SUBJECT: Finding of No Significant Impact
TriRiver Water (Formerly City of
Sanford)
Pittsboro Force Main and Lift
Station Amendment No.2
PROJECT #: CS370413-06

MEMORANDUM

Subject: Amendment to FONSI for Town of Pittsboro (TriRiver Water)
Force Main and Lift Station ER/EID Amendment No.2
CWSRF Project No. CS370413-06
SCH File # 22-E-4300-0258

FIGURE 2
CITY OF SANFORD
 PITTSBORO LIFT STATION SITE MAP

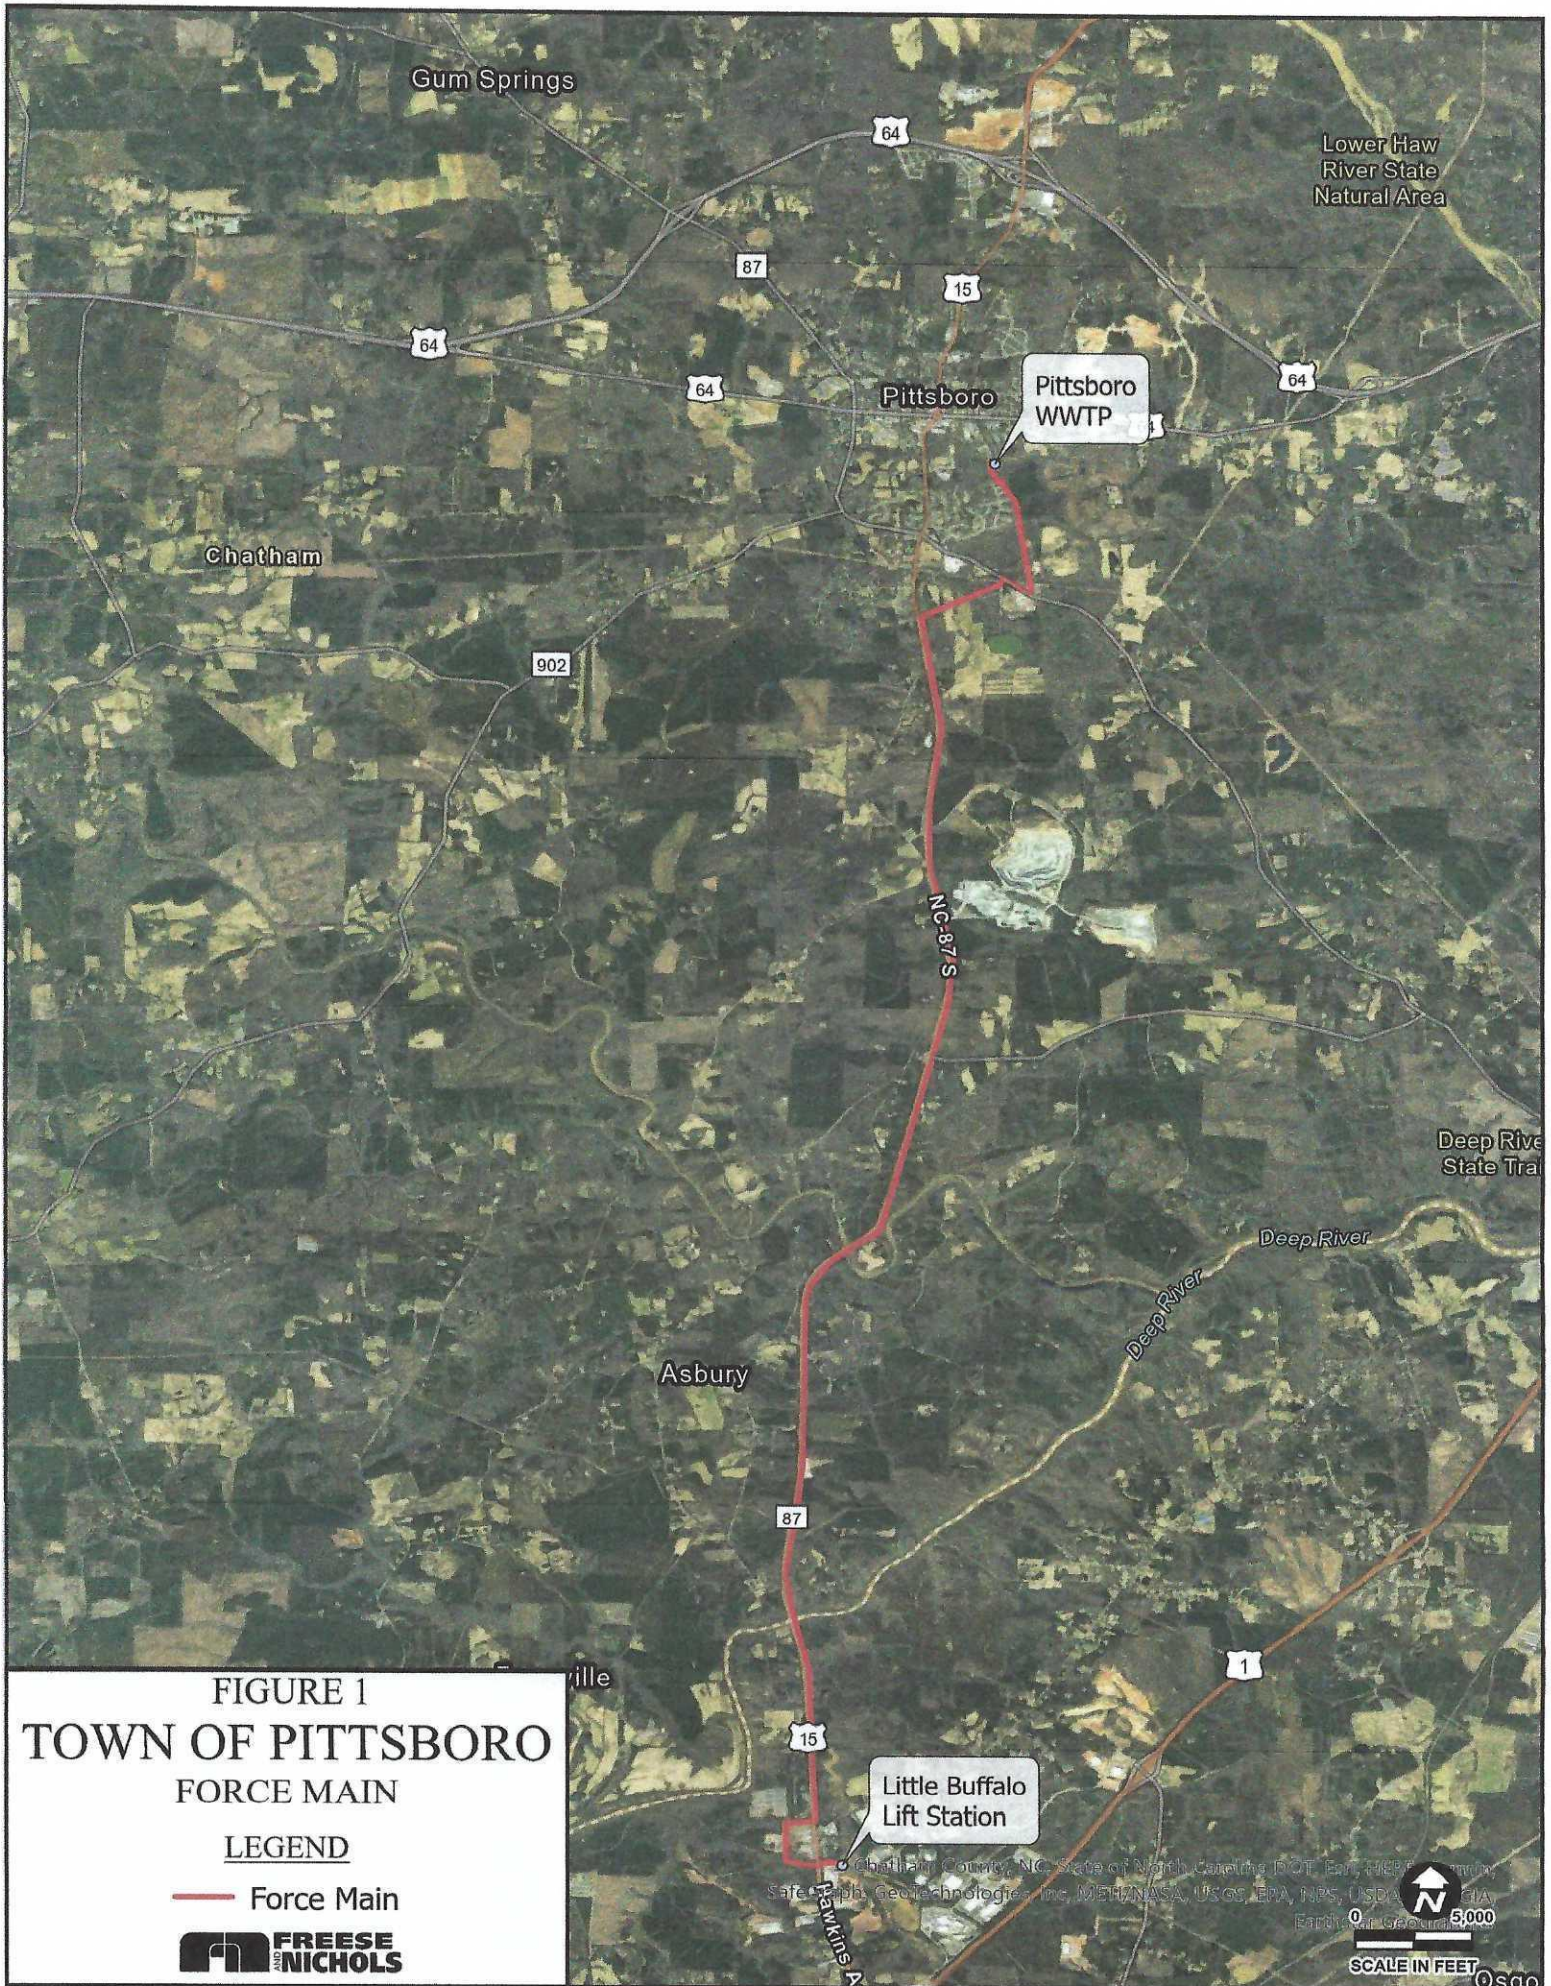
The revised Pittsboro Lift Station (PLS) is designed for a future capacity increase, as needed. The station will initially have two pumps with a firm capacity of 2- MGD ADF. The PLS is expandable to four pumps with a firm capacity of 5- MGD ADF. The revised lift station will be constructed within the bounds of the original planned site. The originally planned decommissioning work at Pittsboro WWTP will be deferred approximately 15 years and removed from this project to allow the plant to continue to operate at its current permitted capacity. The anticipated cost for the decommissioning of the WWTP is expected to be minimal and will be funded at a later date. Foregoing the work to decommission the WWTP decreases the limit and type of environmental disturbances by 0.77 acres.
